MIGIZI GROUP, INC.

February 7, 2019

Subject: Geotechnical Review of November 1, 2016 WAC 197-11-960 Supplement
Proposed Amendment to Statewide General Permit No. BT9902
19724 128th Avenue S.E.
Yelm, Washington 98597
P/Ns 22602130200, 22602130100, 22602130000, 2260212000, 22602110100,
22602140100, 22601230000, 22602140000

Map provided by MyTopo.com

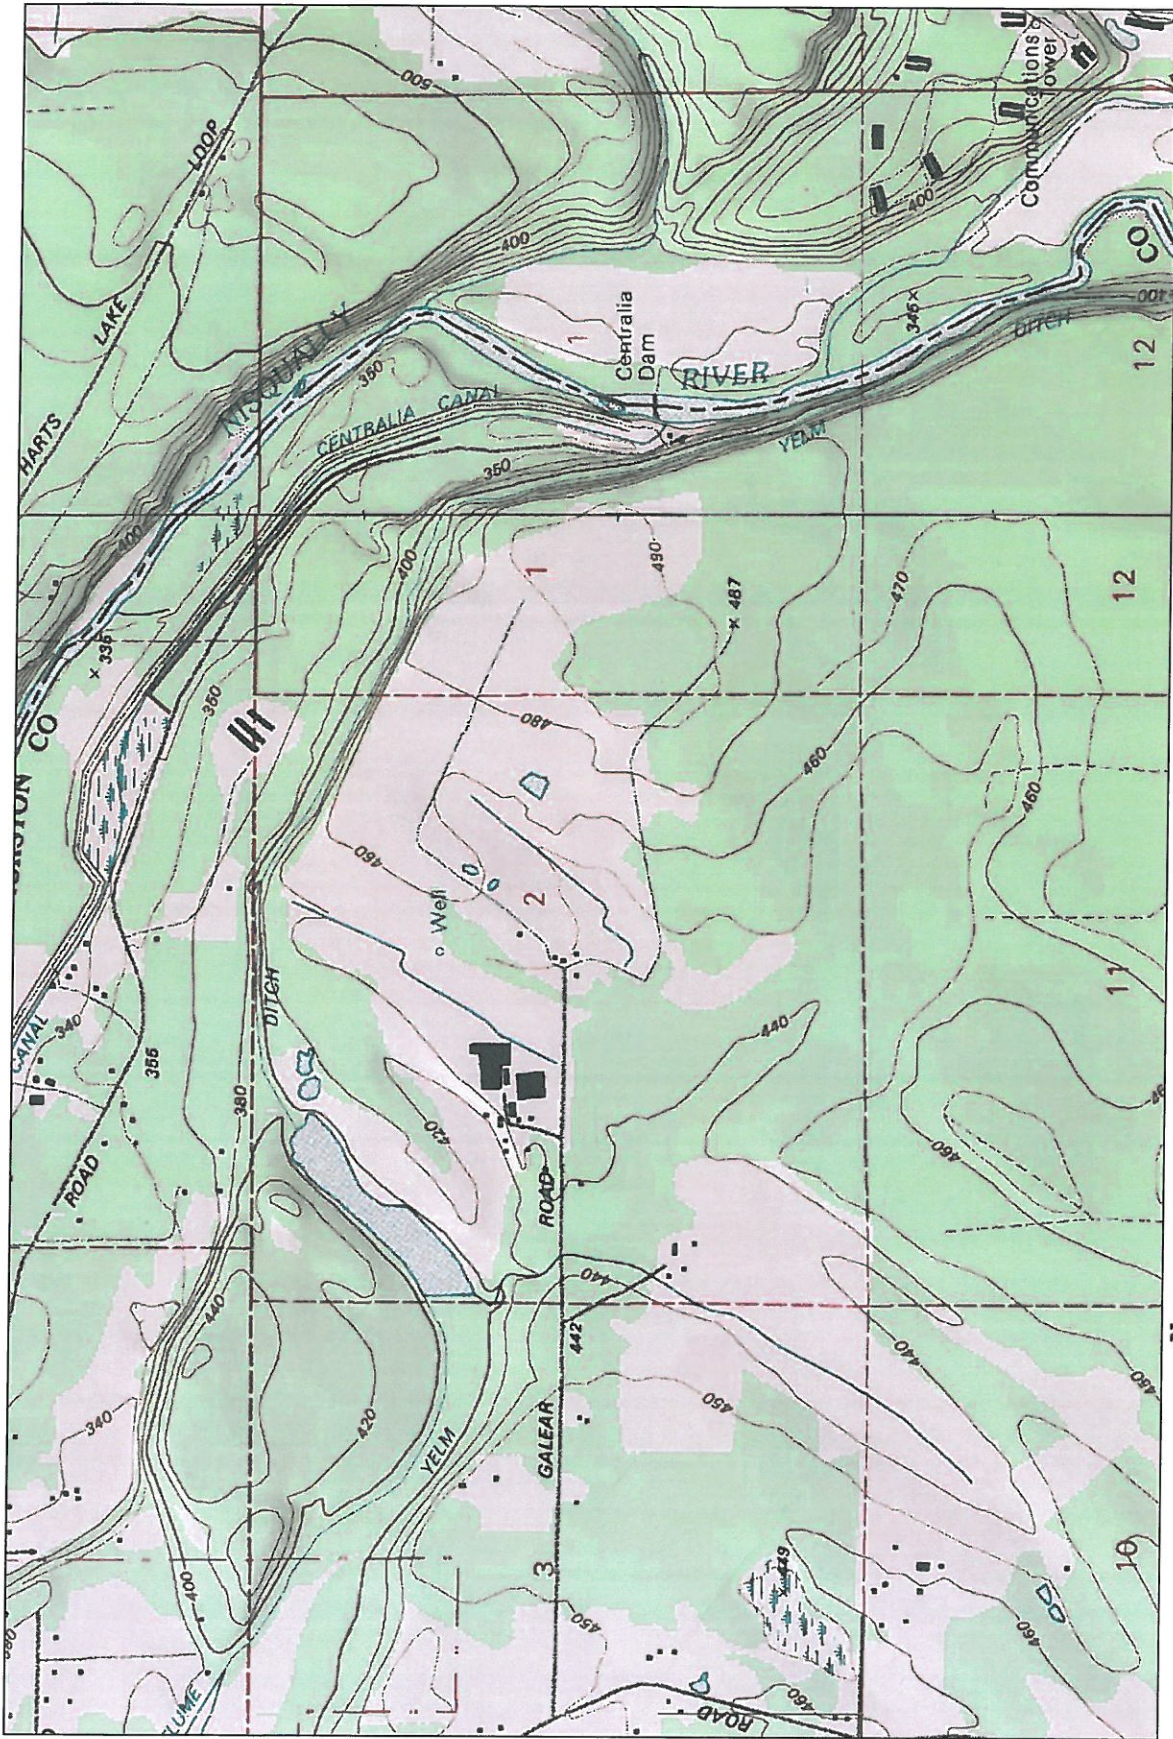
The applications state that the site “is a generally flat area with some rolling areas (*SEPA Checklist B. ENVIRONMENTAL ELEMENTS 1. EARTH a.*) Yet the attached United States Geological Survey (USGS) topo map of this area indicates that site elevations are 460-490 ft. on the site and then drop off to around 330 ft. at the surface of the adjacent Nisqually River located to the east. The supplemental application, under *SEPA Checklist B. ENVIRONMENTAL ELEMENTS 3. WATER a. Surface* states: “This site is 1,000 feet from the Nisqually River”.

The USGS map also indicates a downhill gradient to several manmade lakes that flow into Wheeler Creek to the west. The surface elevation of Wheeler Creek is about 400 ft. within a distance of about a ½ mile. This creek also passes through a large wetland area. So the site is basically a topographic hilltop for the area with elevations dropping significantly only a short distance off site.

Attachments: *United States Geological Survey (USGS) Topo Map*
Portion of Washington State Department of Natural Resources (DNR) Geologic Map of
the Area

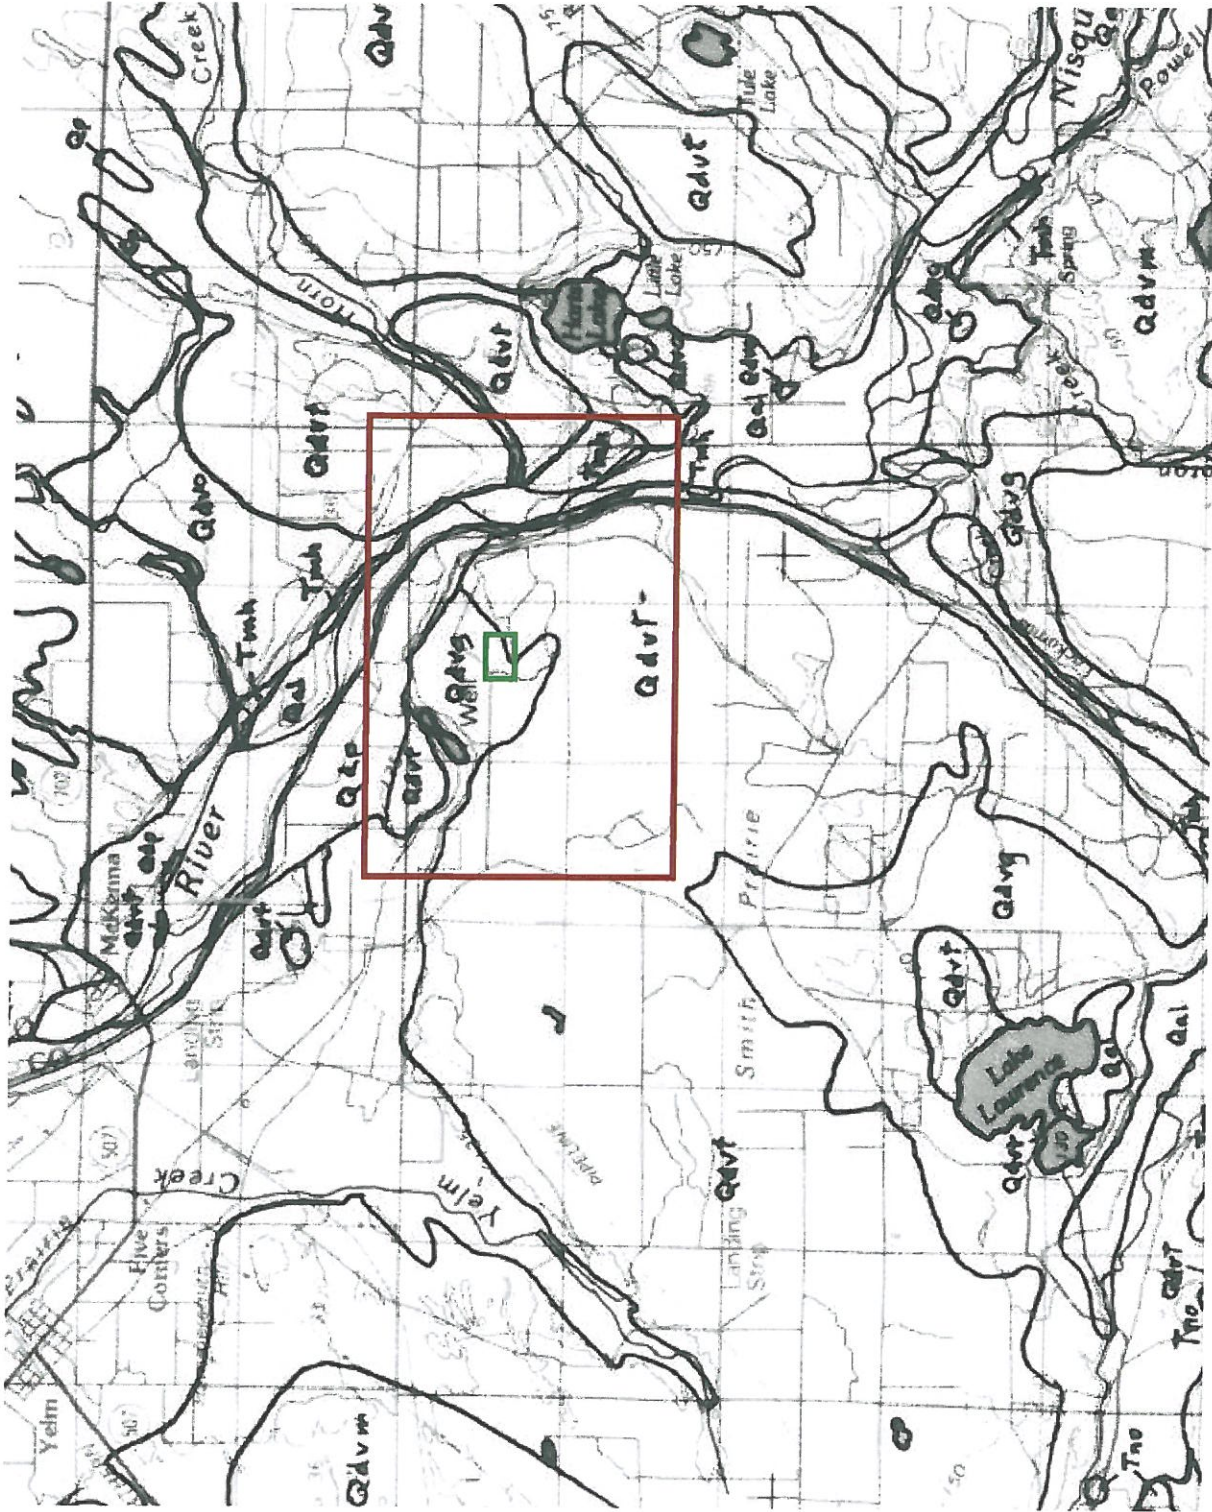
The above soils listing comprises an agronomy listing of the surficial topsoils in the vicinity, as determined by the United States Department of Agriculture (USDA). The Washington State Department of Natural Resources (DNR) geologic map of the area (portion attached) indicates that the site soils at depth may be expected to be **glacial till** at the higher elevations (475 ft.) overlying **glacial outwash** at the lower elevations.

Glacial till generally consists of sand, silt, and gravel mixtures deposited below glacial advance and then compressed by ice to a very dense condition. The density of this material can approach that of concrete. The surface of this material has weathered over the past 7,000 years or so after the glacier retreated. This weathered zone typically consists of topsoil and water softened soils. However, due to the density of the underlying unweathered soils, surface water typically perches at the weathered/unweathered interface and runs laterally down gradient during the wetter portion of the year, which typically runs from October through May or June in Western Washington.

The *SSLAP, 10.0 Groundwater Protection Plan* states: "Fire Mountain Farms will not apply to fields where depth to the water table is less than three feet, or during a time when water table is near three feet and rising." Biosolids **cannot** be sprayed if perched groundwater is present within this depth, so this part of the site is largely unusable for most of the year. Lacking a comprehensive soil investigation, the mapped size of this area alone is sufficient to render this site as unsuitable for biosolids applications.

Glacial outwash typically consists of sand, gravel, and cobble-sized soils deposited by meltwater runoff during glacial advance or retreat. This material is widely used as an aggregate resource in the Pacific Northwest and has recently been mapped by the Thurston County Resource Inventory. **Glacial outwash** is typically highly permeable and can be expected to infiltrate surface water to the regional water table with minimal filtering. As outwash deposits are also a source of water for many domestic wells, the introduction of sludge/"biosolids" to the aquifer recharge surface area is short sighted at best, and potentially introduces pathogens, heavy metals, etc. (see list above) to the groundwater in this area.
